## **PARTS BULLETIN**

### **Robertshaw Gas Valves**

Bulletin #: P279

### **Identifying A Reworked Valve**

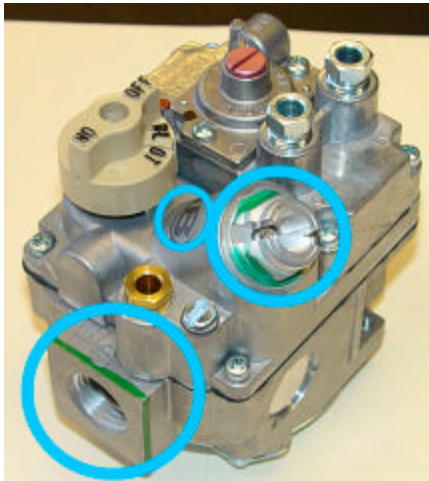
If Robertshaw has reworked the valve in the factory, the valve will be marked with a green stripe on the inlet side of the valve body, and may also have a green stripe on the magnet as well as a black circle with a letter in the center, stamped on the body.

If Robertshaw reworks the valve in the field, the magnet will have a green strip on it.

In either case, if the valve has been identified as reworked by Robertshaw, it is no longer included in the 7000 series recall, regardless of the date code on the valve body.
